Date: Monday 18, Tuesday 19, Wednesday 20,
Thursday 21 and Friday 22 November 2024
Time: 9.30am
Meeting room: Council Chamber
Venue: Ground floor, Auckland Town Hall
301/317 Queen Street, Auckland

PRIVATE PLAN CHANGE 94
HEARING REPORT VOLUME 3
WAIRAKA PRECINCT IN CARRINGTON ROAD,
MT ALBERT
MINISTRY OF HOUSING AND URBAN
DEVELOPMENT – HANNAH MCGREGOR

Figure 6. Mock up plan prepared by the author showing the location of potential three neighbourhood parks along with other open spaces within Wairaka precinct.

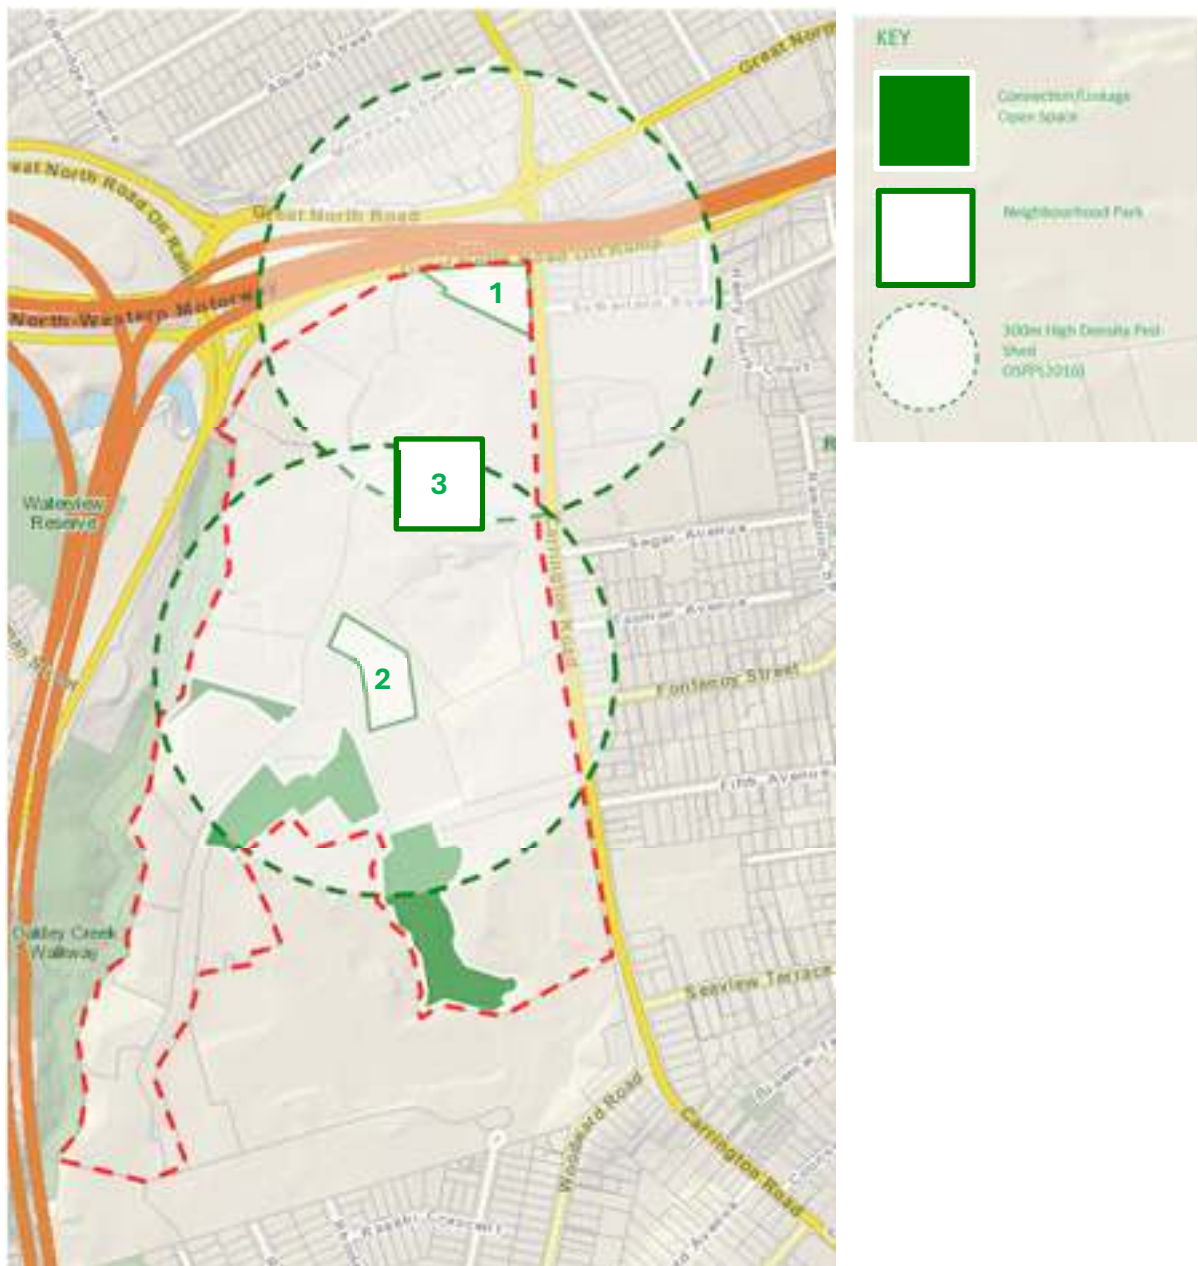
- 3.56 In addition to the above open spaces, I support the need for the provision of another open space as a neighbourhood park which I consider is necessary to meet Council’s parks provision policy from a catchment perspective. The following mock up plan (Figure 6) shows three open spaces identified as potential neighbourhood parks contributing to the open space network within the precinct along with other open spaces identified as those providing for other purposes within the precinct.
